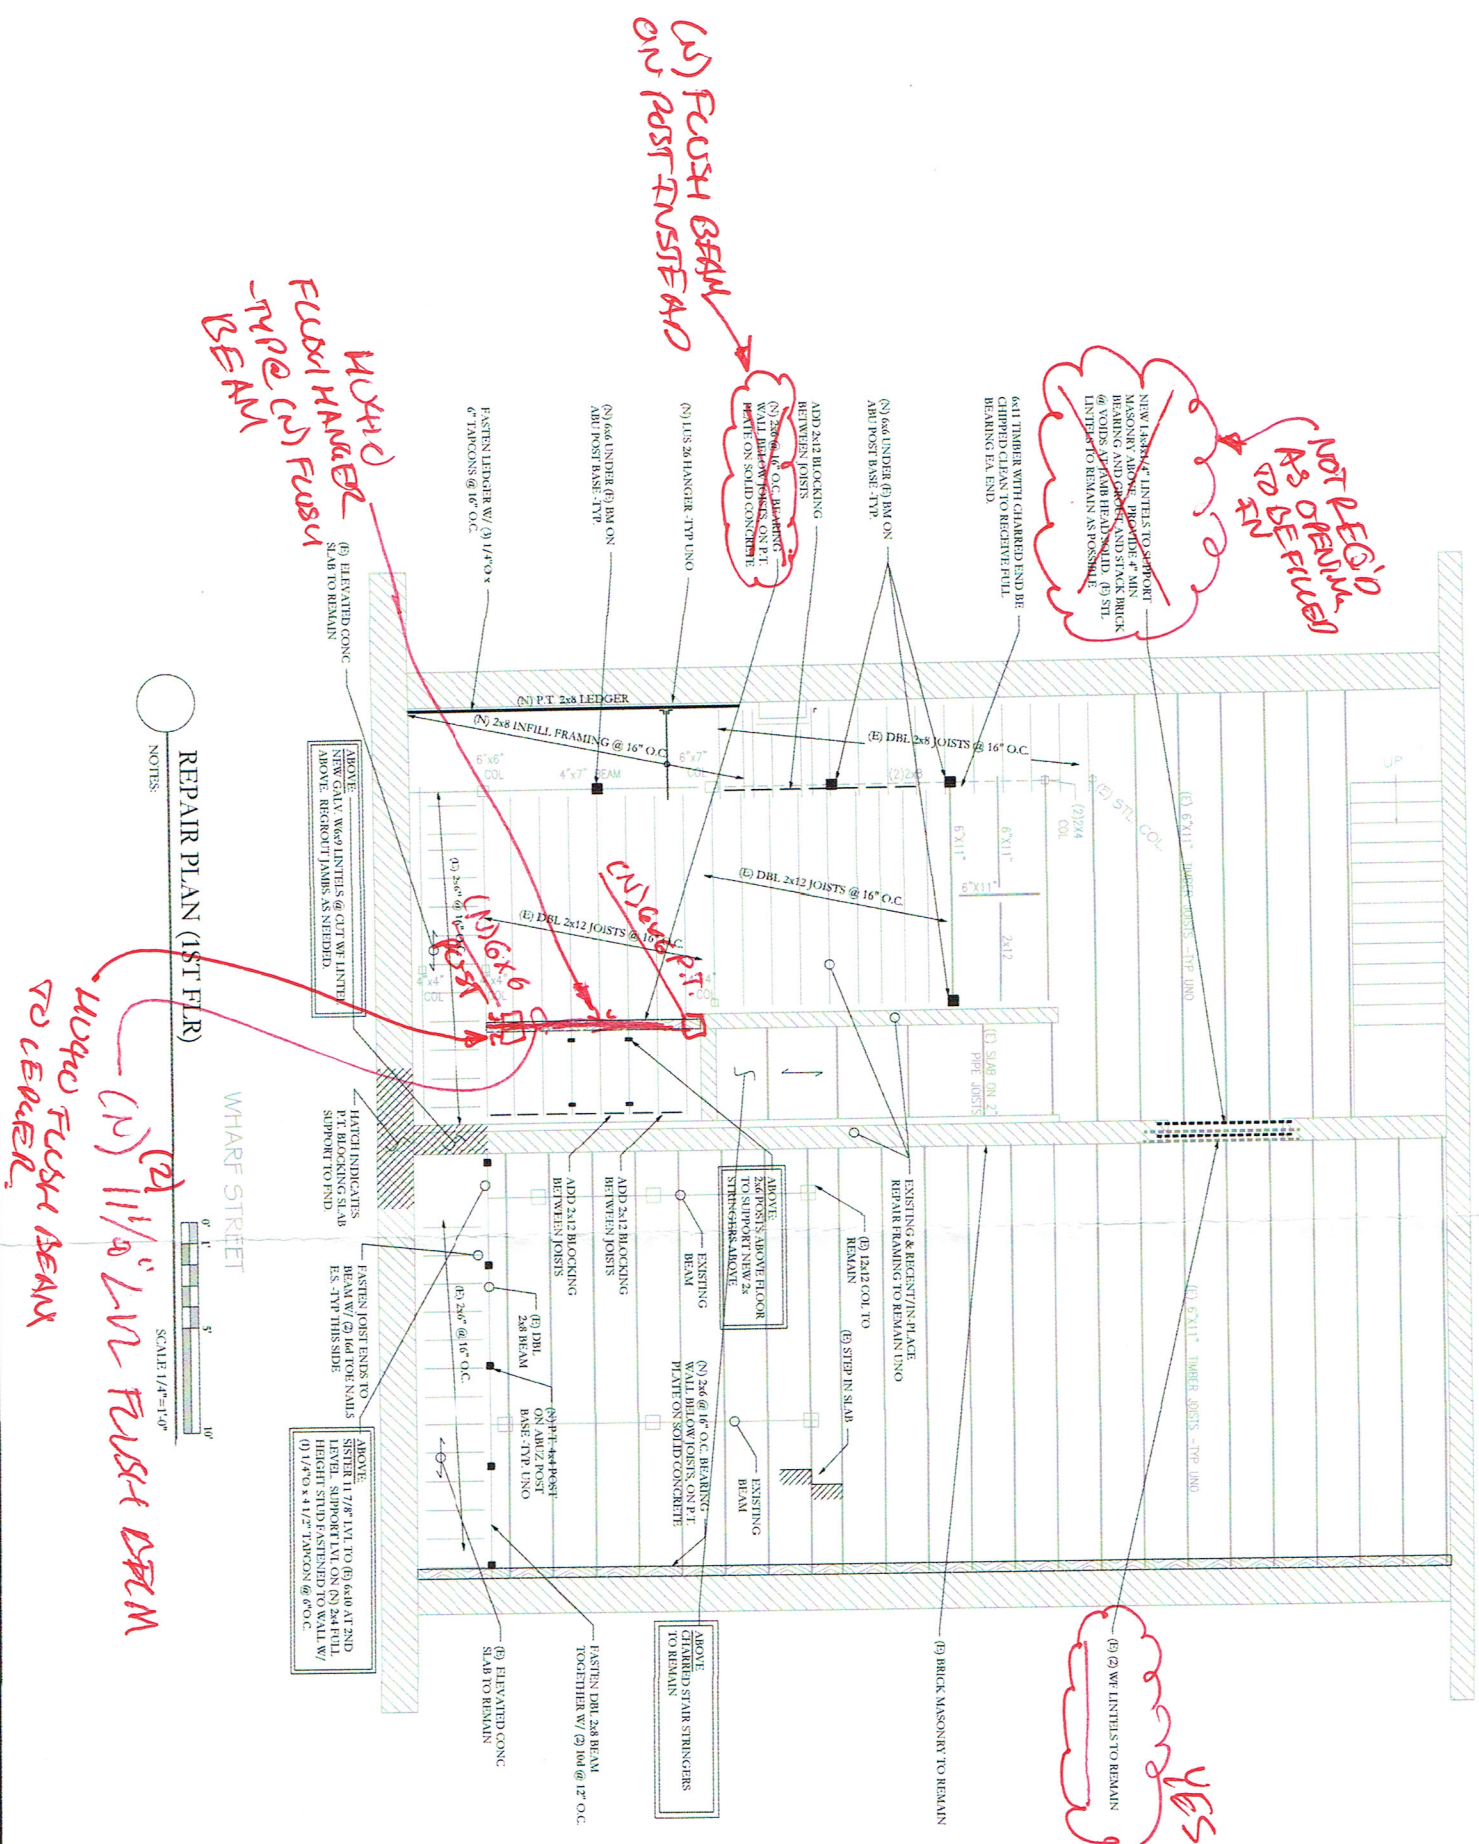
NOT REQ'D AS DEFICED TO EN

(S) FLUSH BEAM ON POST INSTEAD

(N) 11/8\"/>
